FINAL SAFETY ANALYSIS ADDENDA
TO HAZARDS SUMMARY REPORT,
EXPERIMENTAL BREEDER REACTOR II (EBR-II):
UPGRADING OF PLANT PROTECTION SYSTEM,
VOLUME I

ARGONNE NATIONAL LABORATORY, ARGONNE, ILLINOIS

This report is a compilation of the formal Final Safety Analysis Addenda (FSAA's) to the EBR-II Hazard Summary Report and Addendum that have been prepared in support of certain modifications to the reactor-shutdown-system portion of the EBR-II plant protection system. Each major section is an edited version of the original FSAA for a particular modification and provides a description of the pre- and post-modification system, the rationale for the modification, and required supporting safety analysis.

2. EBR-II PLANT MODIFICATION NO. WAF-796: UPGRADING OF REACTOR SHUTDOWN SYSTEM

Fig. 1. Schematic Diagram for Shutdown System B

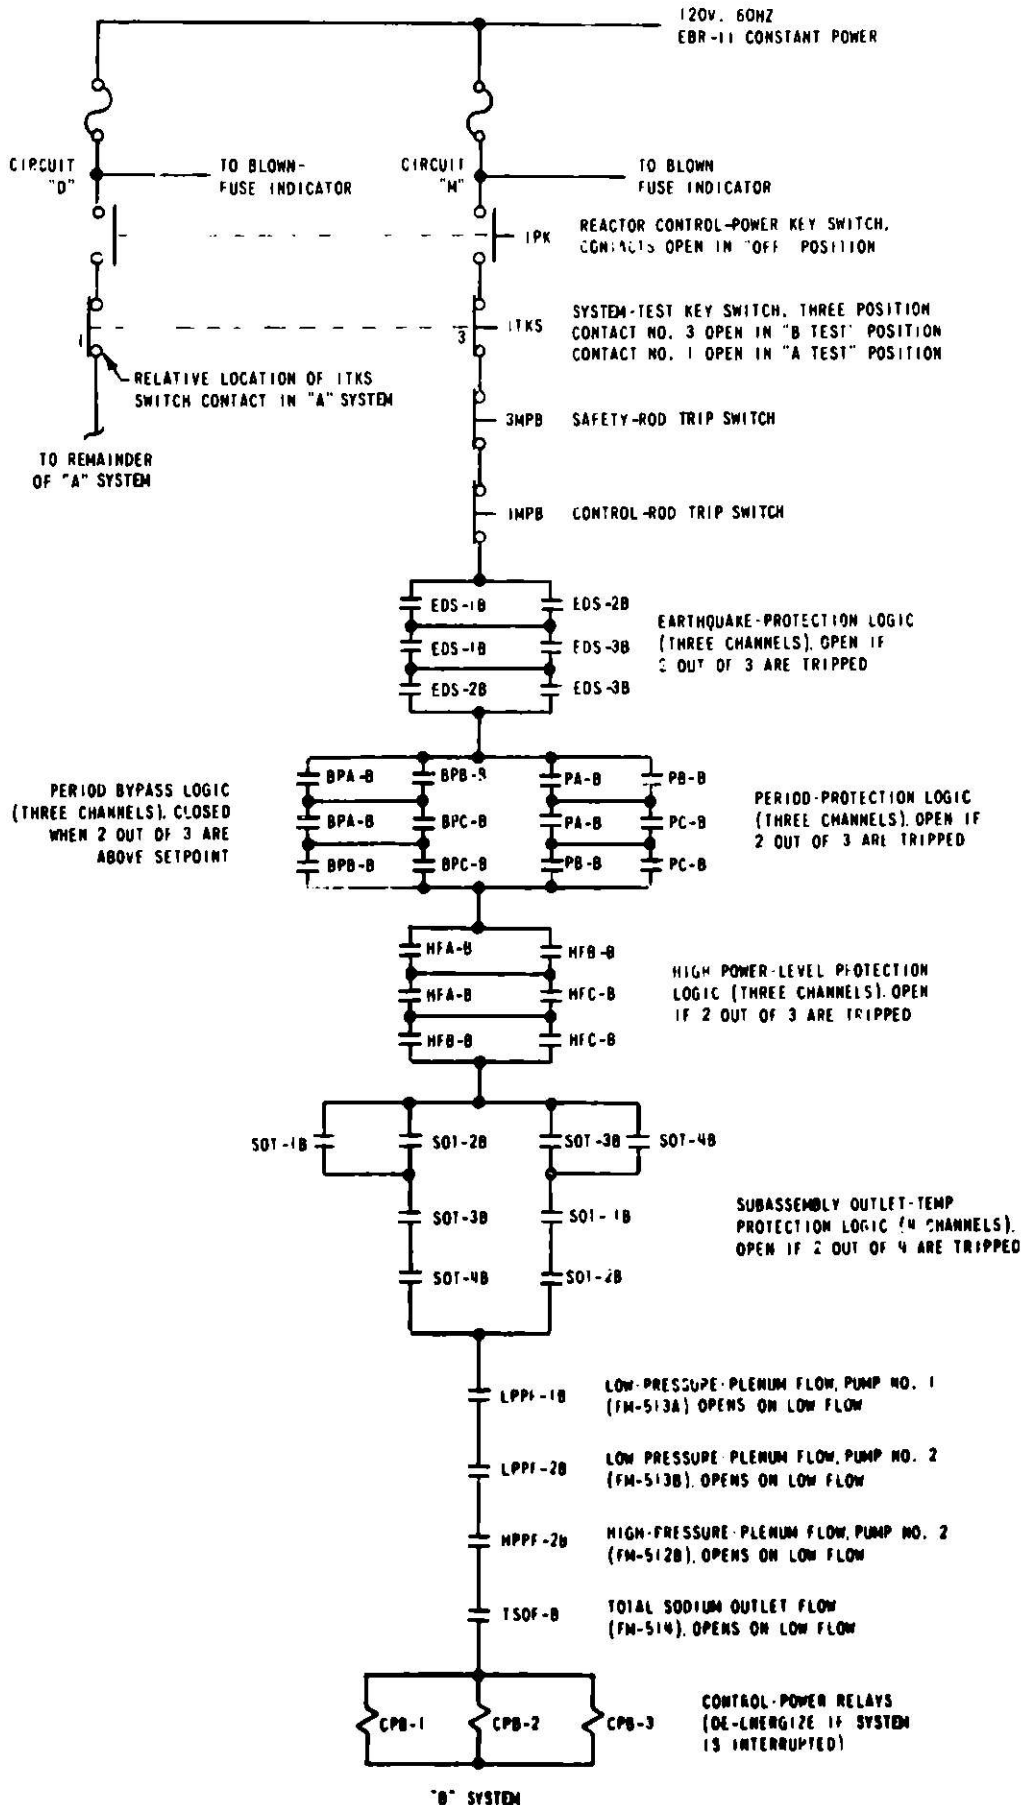
Shutdown system A is modified to incorporate contacts from the string test key switch ITKS described in Sec. 2.3.1. These contacts are connected in system A immediately after the contacts of switch 1PK, as shown in Fig. 1, to coincide with the arrangement for system B.

Fig. 14. Reactor Shutdown System after Installation of WAF-753

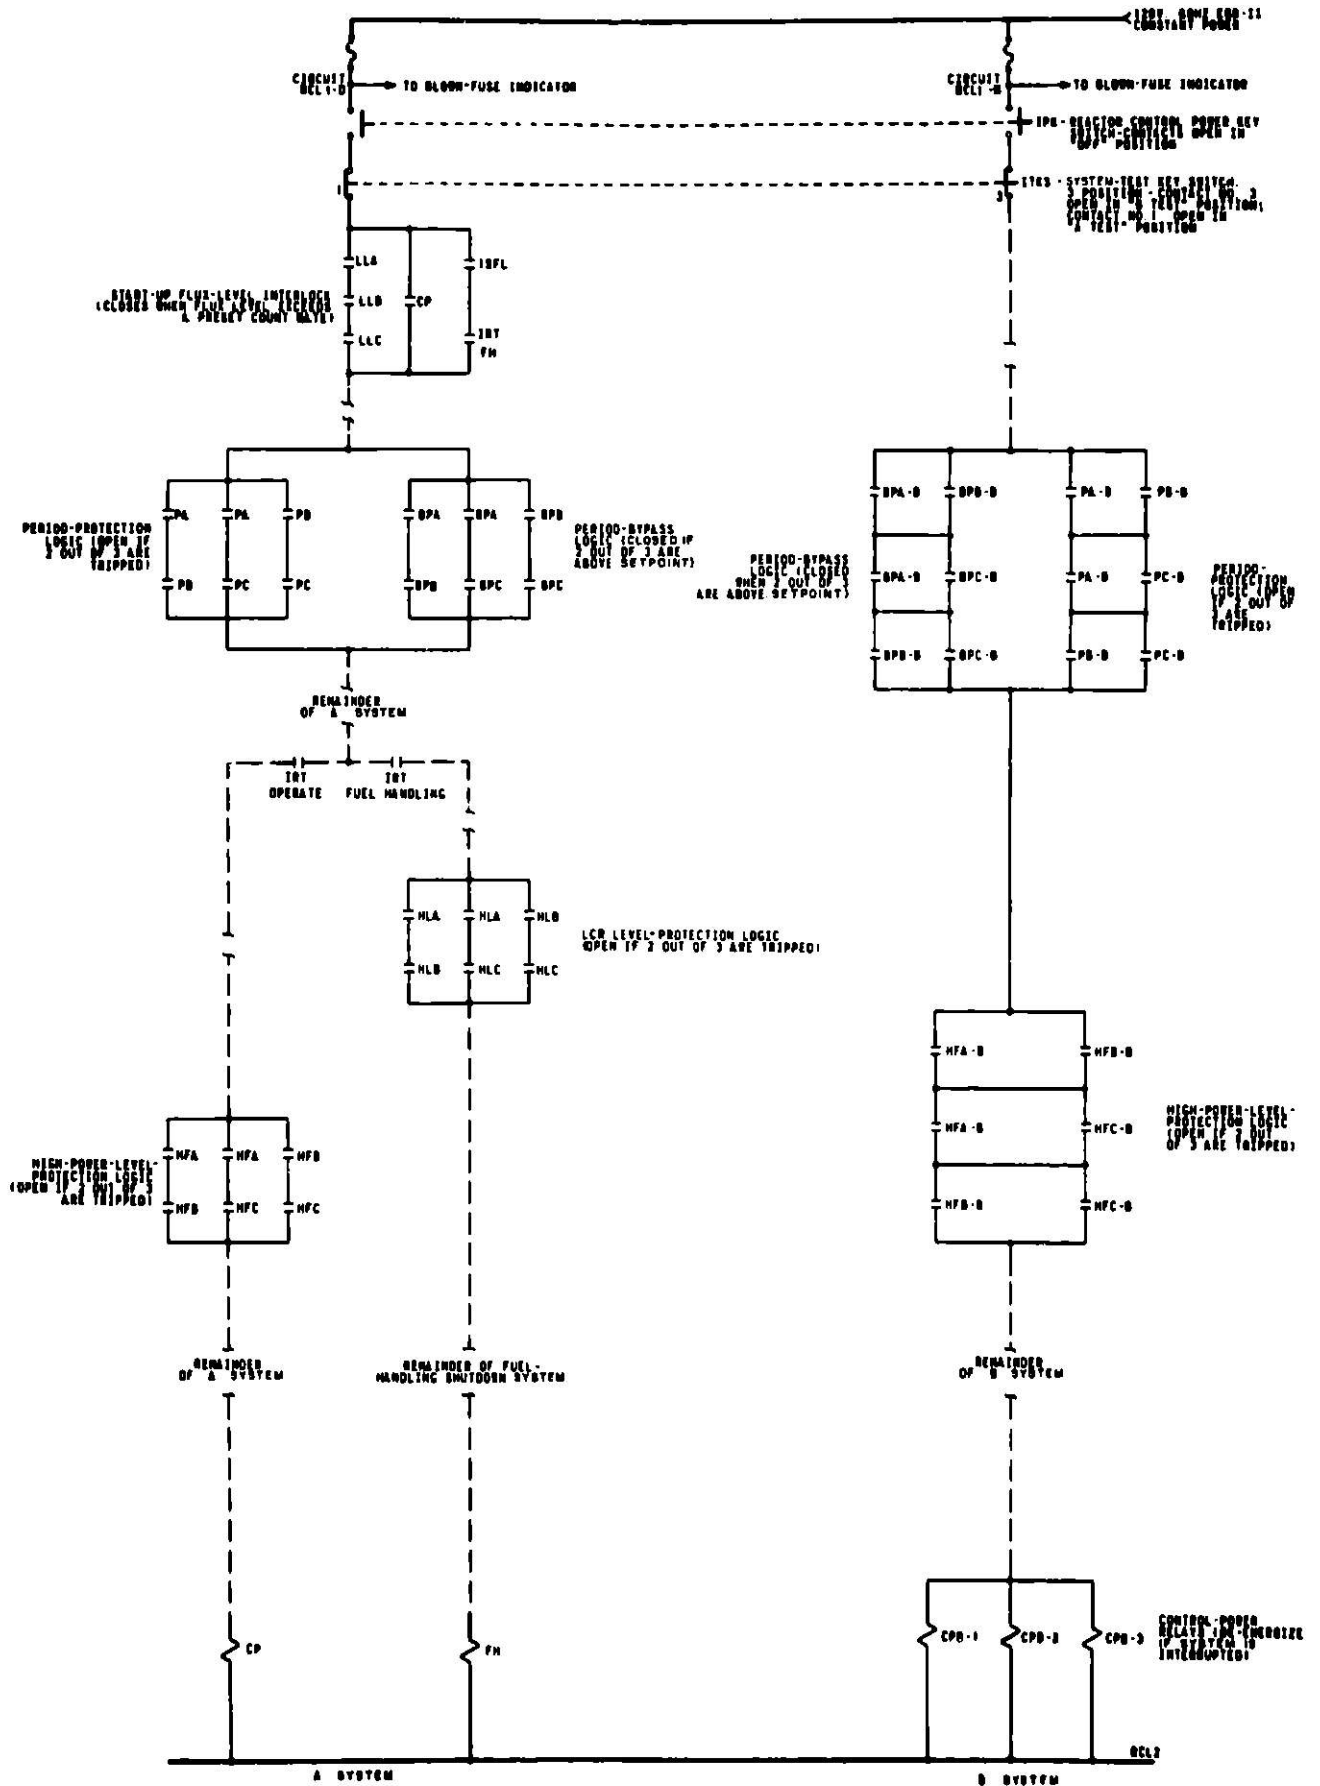
Figure 14 shows the arrangement of the W-R channels in the shutdown circuit. The shutdown circuit common to both the fuel-handling and

Fig. 26. Partial Diagram of Shutdown Circuit. Showing Flow-related Trip Contacts before and after Completion of PM 443

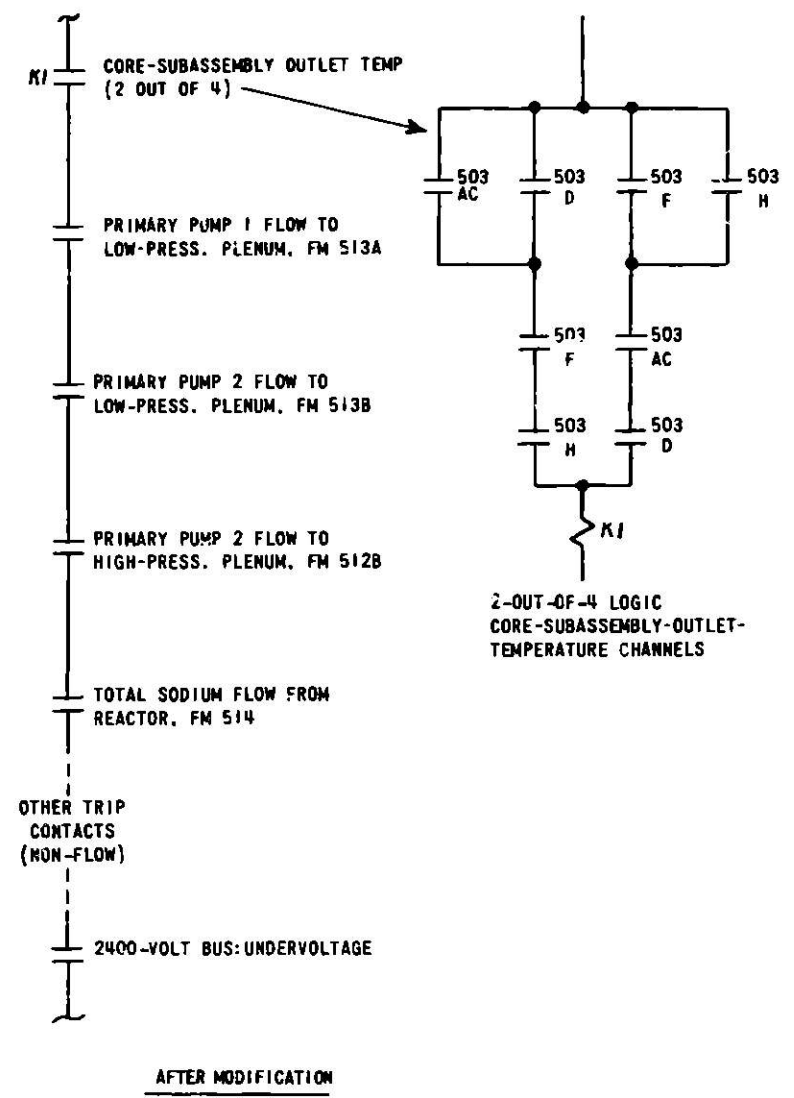
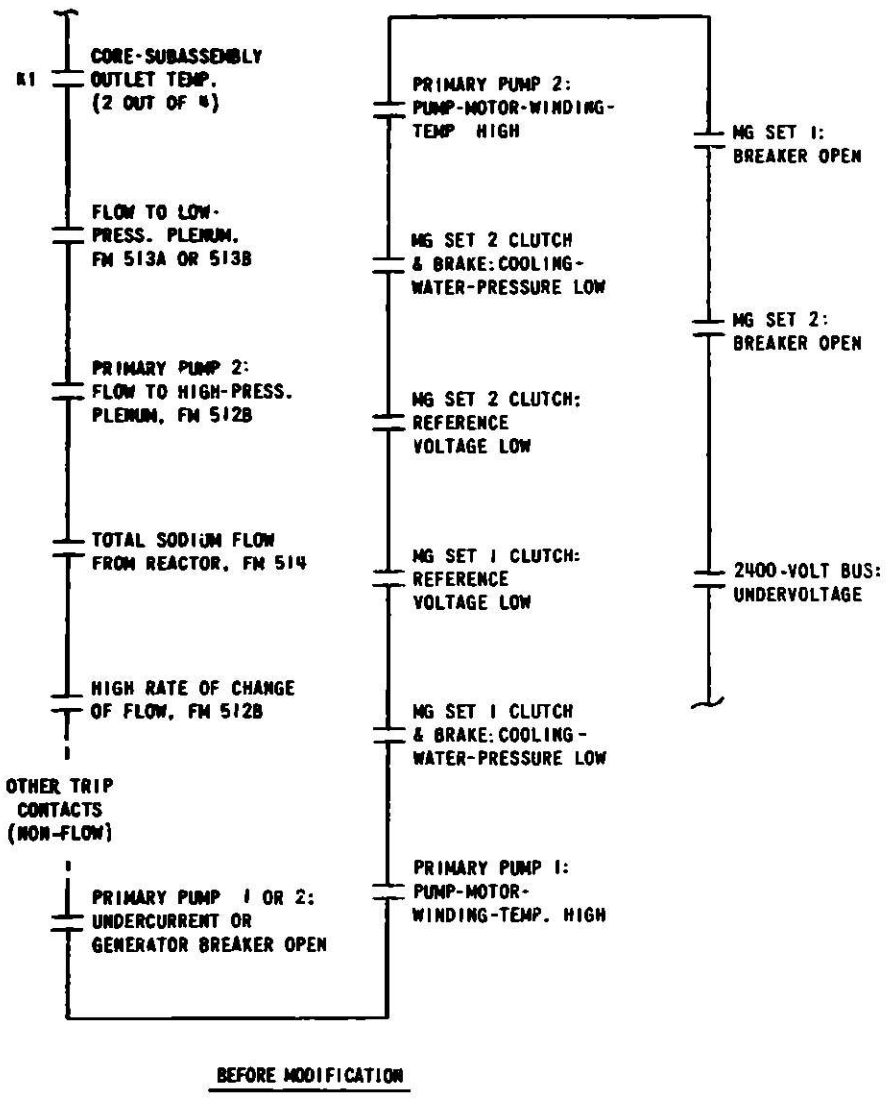
The affected sections of the shutdown system before and after the modification are shown in Fig. 26. The modified system does not contain relay contacts for the deleted trip functions, and separate relay contacts are provided for each trip that responds to low coolant flow in the low-pressure plenum.

Fig. 37. Arrangement of Rod-latch Contacts in the Shutdown and Alarm Circuits after PM 404

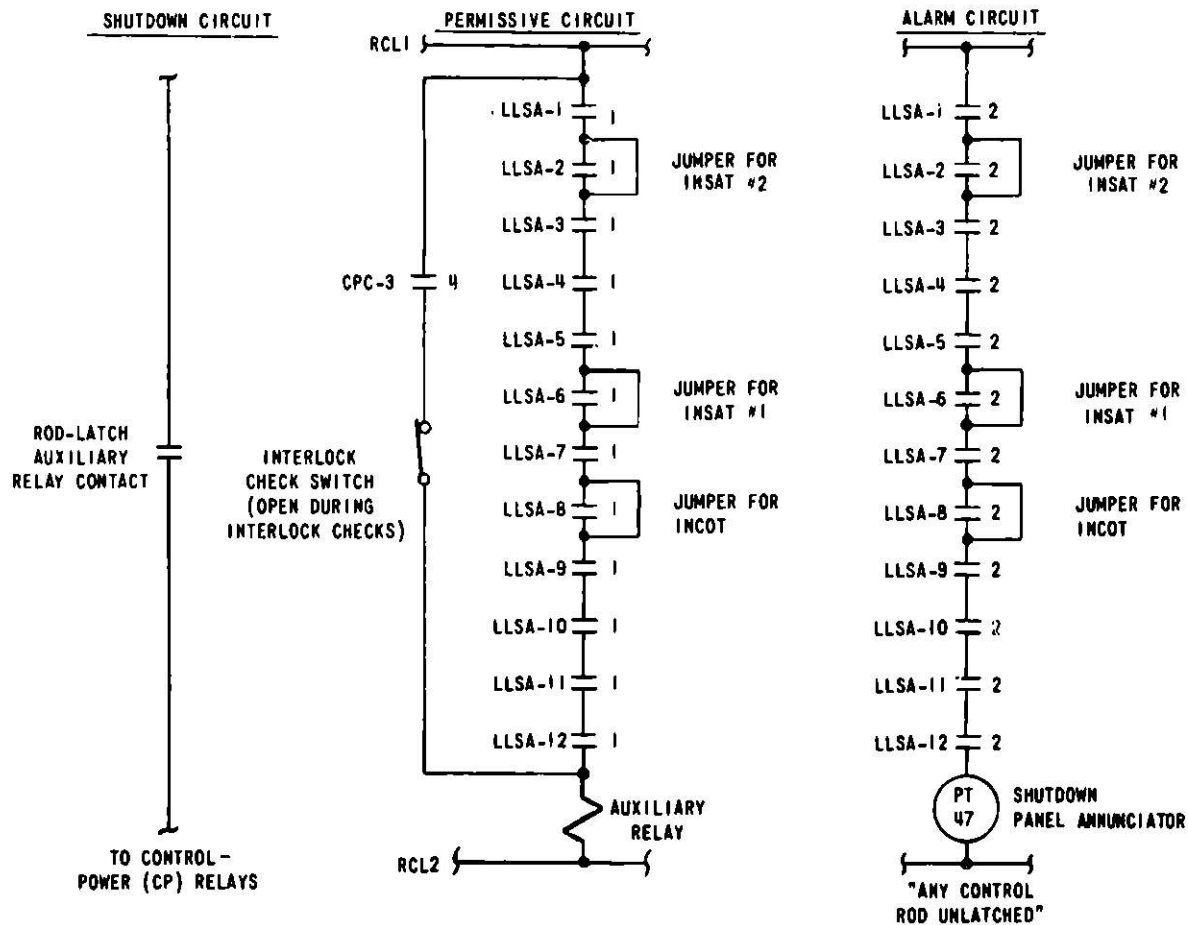
Figure 37 shows the circuitry of the modified system, in which the control-power (CP) relay contact is in parallel with the rod-latch relay

contacts in a permissive circuit. The all-rods-latched condition is a "permissive" condition required for startup. To initially energize the CP relay, all rods must be properly latched. Once the CP relay is energized, the CP contact closes and the unlatching of a rod will not activate the shutdown system.

The administratively controlled bypass contact for reactivity rod-drop tests (shown in parallel with contact LLSA-1-1 in Fig. 36) was removed. This contact was used to avoid a trip when control rod No. 1 was dropped for reactivity tests, and it is not required in the modified system.

Fig. 38

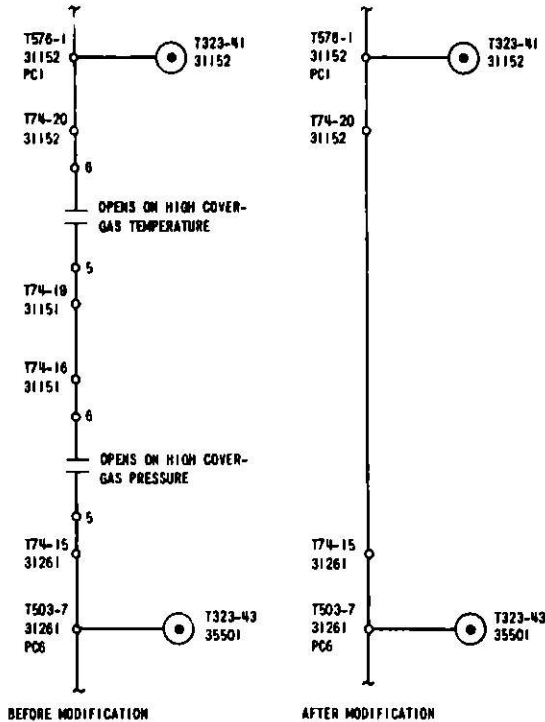
By this modification, the trips for high cover-gas temperature and pressure were removed. Figure 38 shows the affected section of the shutdown system before and after the modification, in which one jumper wire was installed and the wiring to the relays no longer required was removed.

Fig. 42
Bulk-sodium-temperature Portion
of Shutdown Circuitry

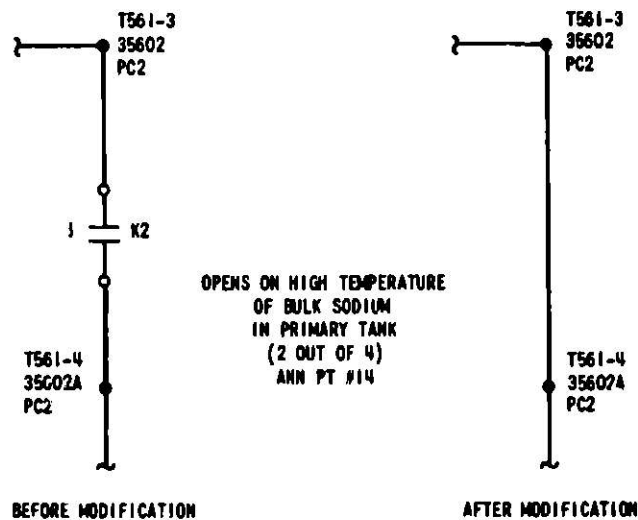
In this modification, trips for high and low levels and high temperature of primary bulk sodium were removed. Figure 42 shows the affected section of the shutdown system before and after the modification.

Fig. 45. Reactor-building-isolation Portion of Shutdown System before and after WAF-5088

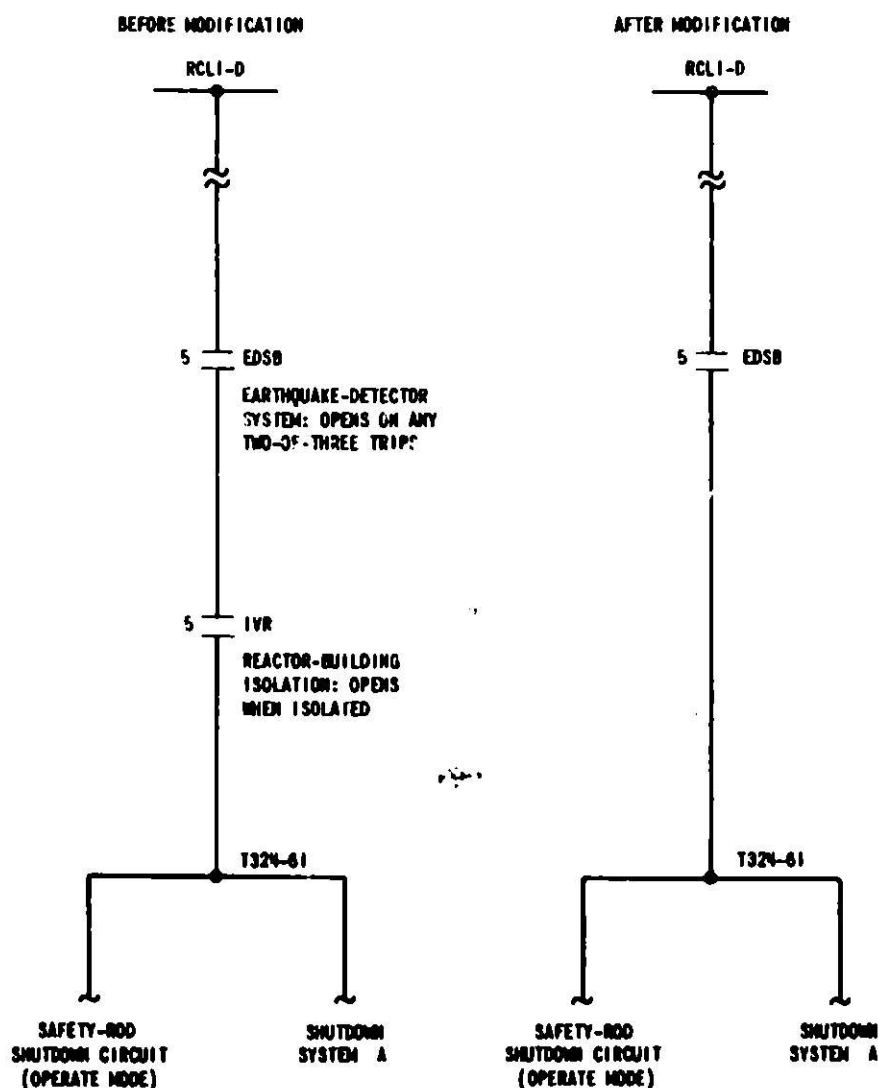
Figure 45 shows the affected section of the shutdown system before and after this modification.
